Access Compliance Report

Public Rights-of-Way

Intersection ID: 50603	Main Street: RHODORA_RD	Cross Street: EMPRESS_CT	Location: NW
ADA ID: 6E2FB417E2F3	Ramp Type: Perp	Initial Pass/Fail: Fail	Overall Compliance: No
Severity Score: 10			
Codes/Mitigation Info/Possible Solution		Field Measurements/Component Compliance

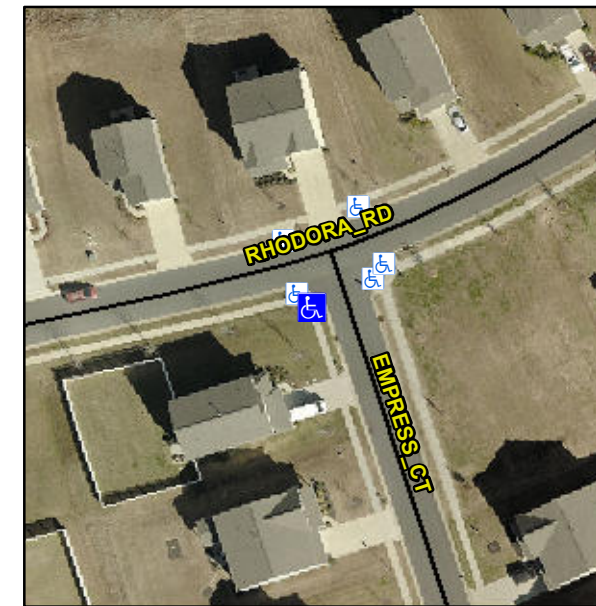
R304.5.1, R304.5.3

Compliance	Description	Data	Compliance	Description	Data
N/A	Ramp Length (in)	48.5	Yes	Ramp Slope (%)	7.3
No	Ramp Width (in)	46.0	No	Ramp XSlope (%)	4.2
N/A	Flare Type LT	N/A	N/A	Flare Type RT	N/A
N/A	Flare Slope LT (%)	N/A	N/A	Flare Slope RT (%)	N/A
N/A	Flare Traversable LT?	N/A	N/A	Flare Traversable RT?	N/A
N/A	Landing Length (in)	N/A	N/A	DWS Provided?	N/A
N/A	Landing Width (in)	N/A	N/A	DWS Contrast?	N/A
N/A	Landing Slope (%)	N/A	N/A	DWS Length (in)	N/A
N/A	Landing X Slope (%)	N/A	N/A	DWS Full Width?	N/A
N/A	Landing Curb? (Y/N)	N/A	N/A	DWS Offset (in)	N/A
N/A	Shared Landing?	N/A			
N/A	Gutter Ponding?	N/A	N/A	Gutter Slope (%)	N/A
N/A	Gutter Lip Ht (in)	N/A	N/A	Gutter X Slope (%)	N/A
N/A	Painted X Walk1?	No	N/A	Painted X Walk2?	N/A
	X Walk 1 Direction	To E		X Walk 2 Direction	N/A
N/A	X Walk 1 Width (in)	N/A	N/A	X Walk 2 Width (in)	N/A
	X Walk 1 Slope (%)	2.3		X Walk 2 Slope (%)	N/A
	X Walk 1 X Slope (%)	3.4		X Walk 2 X Slope (%)	N/A

Remove & Replace Entire Ramp.
